NUCLEAR REGULATORY COMMISSION

Title: Advisory Committee on Reactor Safeguards

Date: Thursday, May 5, 2016

Guidance for Flooding Hazard Focused Evaluation and Integrated Assessment

Closure of Seismic and Flooding Hazard Reviews

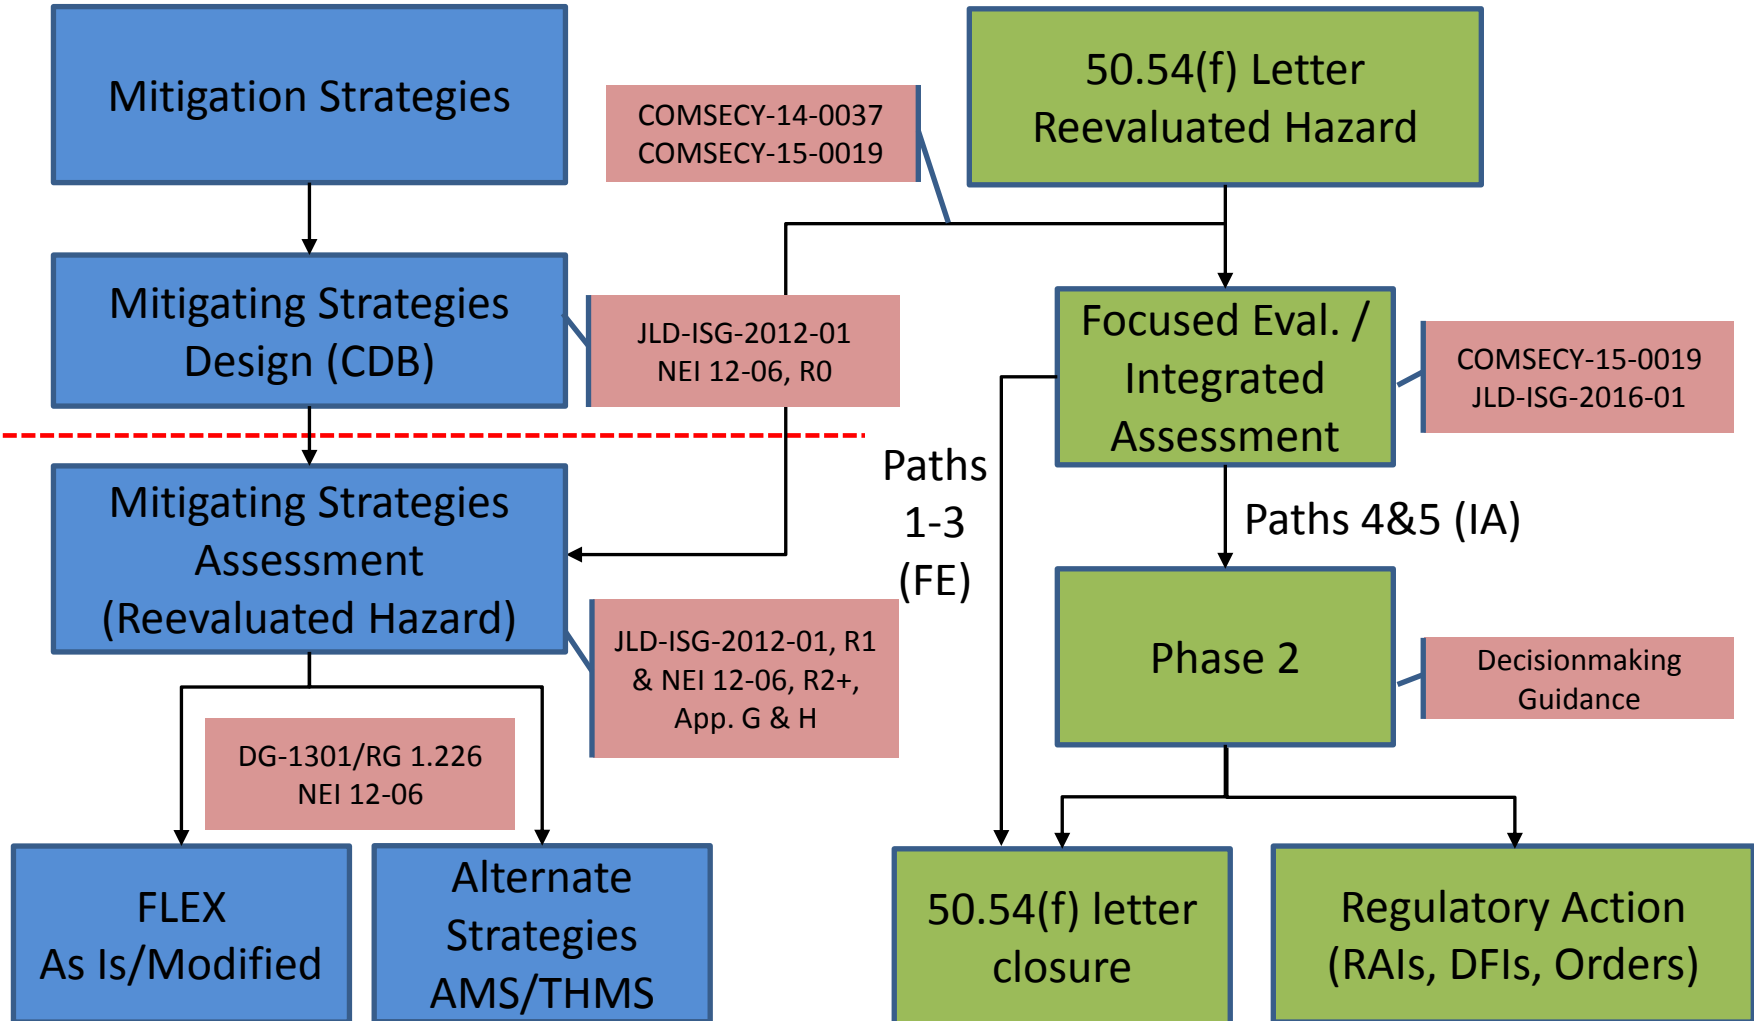
1 by the blue path. The question is how. It's not just
2 flooding.

20 Also, at the end of the green path when
21 one assesses what additional safety enhancements need
22 to be added, one would have to recognize that there
23 are safety enhancements gained already in the blue
24 path and to what degree we want to add beyond what
25 we've already achieved in the blue path.

1 MEMBER RAY: Well, basically, the blue
2 path stems from the idea that we may exceed the design
3 basis. We need to be able to mitigate that. But then
4 it raises the question inevitably to what extent do we
5 not make changes that would otherwise be made in the
6 design basis because we have the mitigating
7 capability. And that's -- I know at the Commission
8 level that's a huge issue for the Agency as a whole,
9 and I just think we ought to try and focus on that
10 enough so that we understand it and it isn't just
11 somewhere in the background, but we don't know how it
12 works.

22 MEMBER REMPE: Just a comment. I
23 appreciate you making this diagram and going through
24 it. It makes it easier to follow, in my opinion.
25 Thank you.

11 Starting on the top left part, after
12 Fukushima Daiichi, we issued the mitigating strategies
13 order. That's Order EA-12-049 and the licensees, the
14 operating power reactor licensees, have been
15 developing and implementing the mitigating strategies
16 taking into account for the most part the external
17 hazards at the current design basis levels. Those
18 levels were informed by other processes going on to
19 the extent that they could. Licensees took into
20 account what they believed would be the outcome of the
21 hazard evaluations that were underway in response to
22 the regulatory instrument on the right-hand side of
23 this vugraph which is the request for information that
24 was issued on the same day as the orders under
25 50.54(f) to reevaluate seismic and flooding hazards.

1 integration of the two bodies of work viewing that the
2 establishment of mitigating strategies that were
3 capable of addressing the reevaluated hazard would
4 provide sufficient safety benefits to essentially make
5 the regulatory decision making for the 50.54(f) letter
6 no longer an evaluated activity.

16 MR. BOWMAN: To finish up the slide on the
17 lower left hand part are the activities going on with
18 the rulemaking that's underway that we also briefed
19 the subcommittee on the 22nd. We have revised
20 industry guidance document, NEI 12-06 Revision 2, that
21 includes Appendices G and H to talk about how they
22 will look at the mitigating strategies for flooding
23 and seismic hazards respectively.

NEI 16-05 Flood Impact Assessment Process

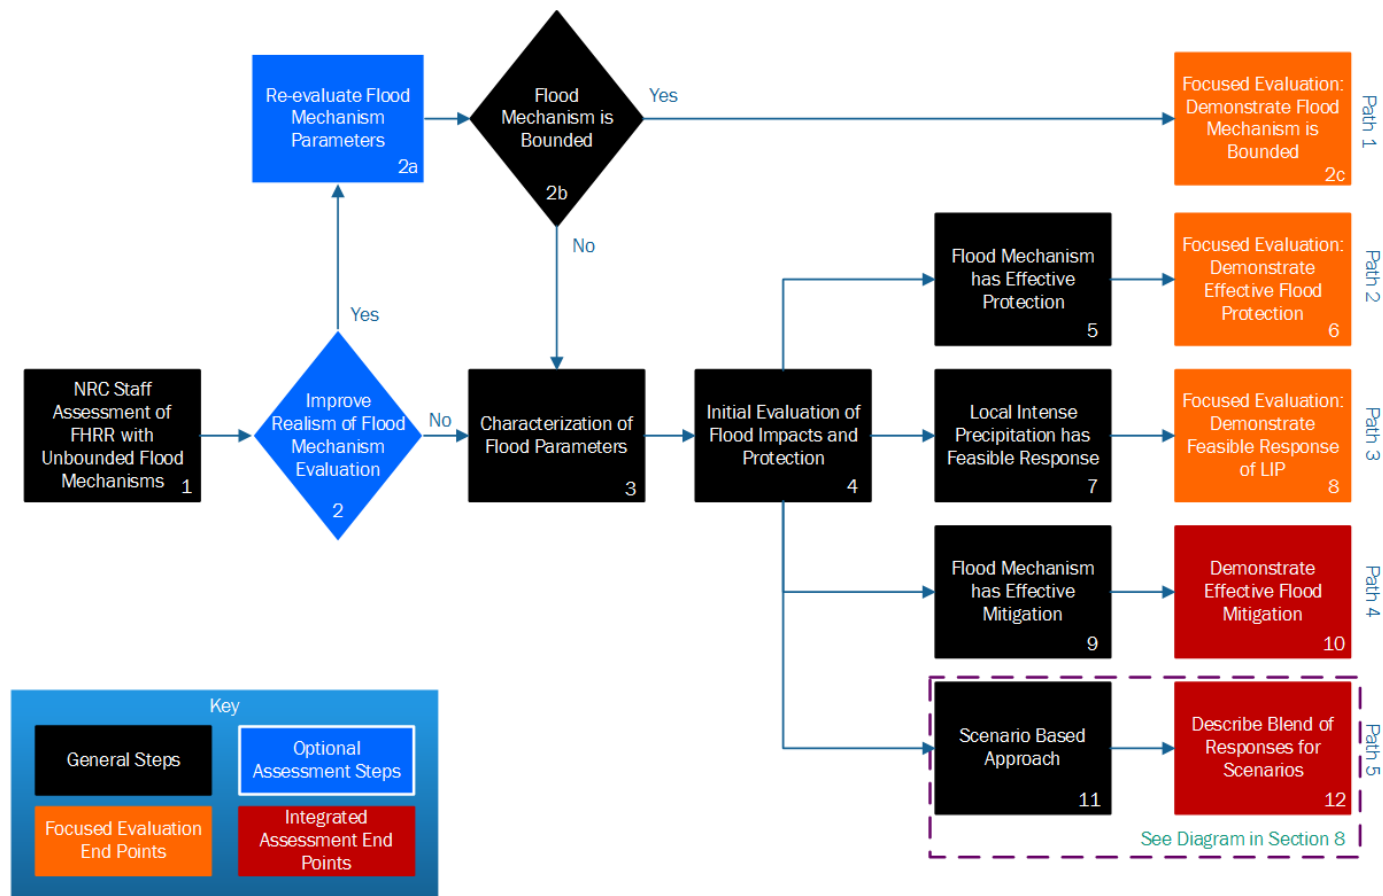
19 Don't give me a history. I want to
20 understand philosophically why mitigation of a local
21 intense precipitation flooding that causes damage
22 inside the plant, that causes damage inside the plant,
23 is treated from your perspective differently than a
24 riverine flood that causes damage inside the plant,
25 because it's being treated differently.

1 MEMBER STETKAR: No, you know that because
2 that event that I just described will be subject, if
3 it causes damage in the plant, to a mitigating
4 assessment that goes through path 4 or path 5 and in
5 the subject to your review in phase 2 for possible
6 regulatory action. It will be by definition.

I included the diagram from NEI 16-05 to show you the different paths that the flooding focused evaluations and revised integrated assessments will go down following their guidance document. The different paths, the ones in the top three on this flow chart are what we term the focused evaluations. The two that end in the red blocks or the bottom two are the revised integrated assessment paths. The reason they're separated in this manner, the ones that terminate in the orange blocks, the focused evaluations, are the ones where the outcome is a

9 We still have that ability to comment on
10 a licensee's approach and say that's still not the
11 appropriate balance of mitigation and protection. But
12 we feel that this is an appropriate hazard to declare
13 up front that a mitigation process for it is
14 appropriate. And we're being responsive to the
15 Commission that says focus the integrated assessments
16 on hazards that are cliff-edge hazards that have the
17 potential for the safety enhancement. And we did not
18 believe that it would fit in there.

NEI 16-05 Path 5 Detail

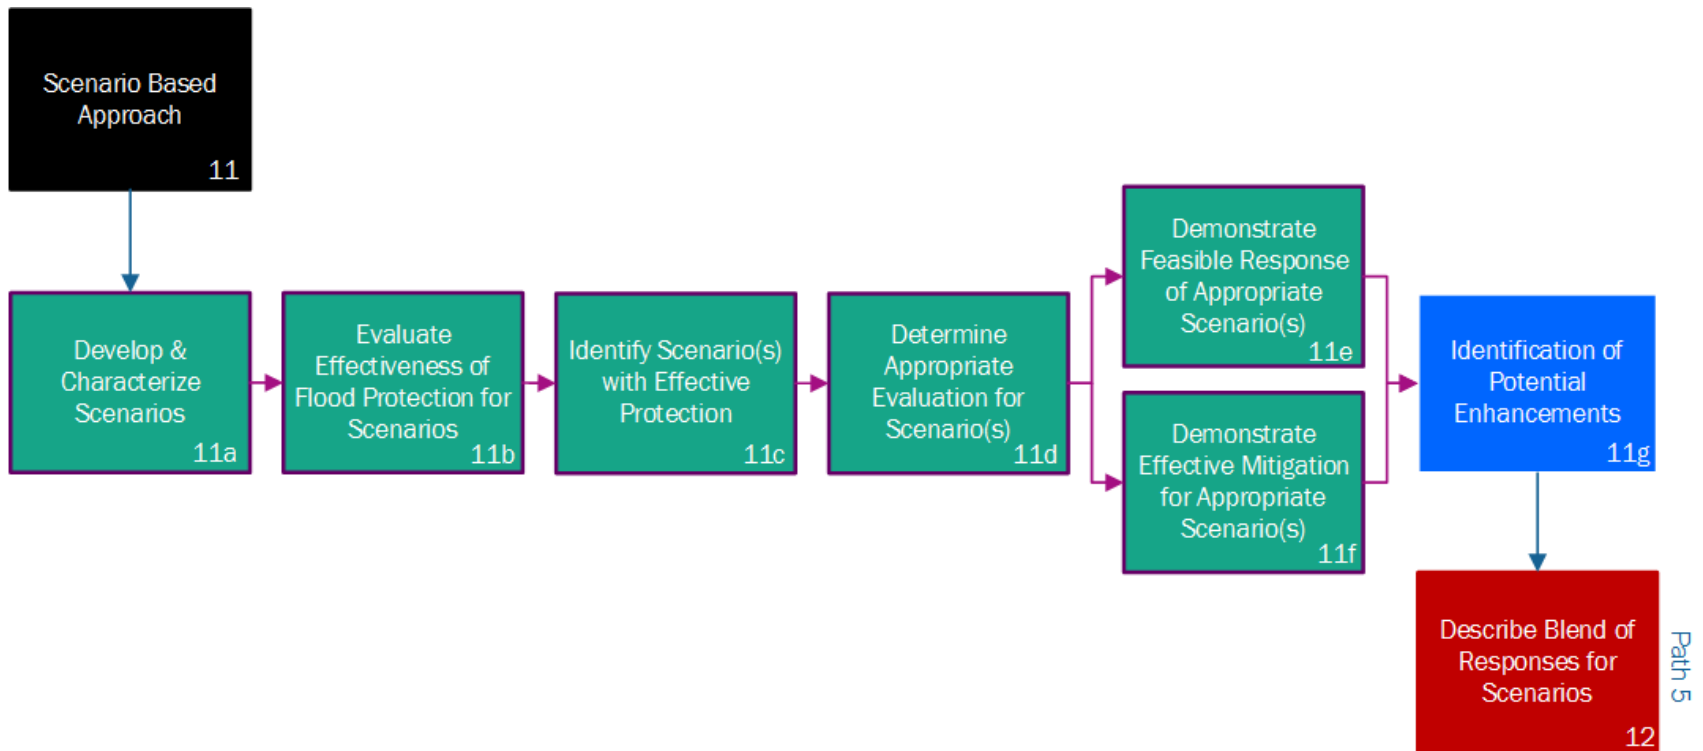
8 MEMBER BROWN: So finish, John, I'm sorry.
9 I just had a question myself. I have a little
10 difficulty with the higher complexity approach by
11 saying this is just too hard.

12 I mean, it's almost similar to me and from
13 the standpoint of looking at the Daichi plants that
14 kind of brushed aside the fact that this has been any
15 induced tsunami and flood would completely flood,
16 overdo their complete plants and wipe them out,
17 because it was very, very, very, very, very, very
18 unlikely. And it's a big, bad thing.

19 And here you've got a very high value
20 asset that's sitting downstream of a major dam or
21 whatever size dam whose complete failure would bury
22 it. I just had a hard time with not, with looking at
23 this thing was just too hard, so the likelihood is too
24 hard to figure out, so therefore we'll do nothing.

12 MEMBER RICCARDELLA: I understand that,
13 but if you can't show that you can do it all the way
14 up, that you can take whatever might possibly happen,
15 that's Path 4, then you can look at Path 5 and say,
16 well, now I can look at the frequency. And if the
17 frequency of the things I can't survive is
18 sufficiently low, then I'm okay. Right? Is that the
19 difference between Path 4 and Path 5?

18 MR. ZACHARIAH: In 4. In Path 5, you
19 would distinguish the critical flood elevations,
20 determine the level of likelihood between those
21 critical flood elevations, and depending on that
22 evaluation, you would determine what the appropriate
23 level of response is required.

1 would make is that I think you're not recognizing the
2 fact that plants have demonstrated effective
3 mitigation for those type of events. Those strategies
4 exist. So the question now becomes whether you need
5 more protection, or whether effective mitigation is
6 enough.

10 MR. ZACHARIAH: Just to add on to one
11 thing Mike said, that we're responding to, it's not
12 that the Path 4 sites wouldn't be doing anything.
13 They would have the burden of having to demonstrate
14 that they have the highest rigor of mitigation for
15 all, for the entire probable maximum flood for that
16 entire mechanism.

20 MR. ZACHARIAH: That is correct.
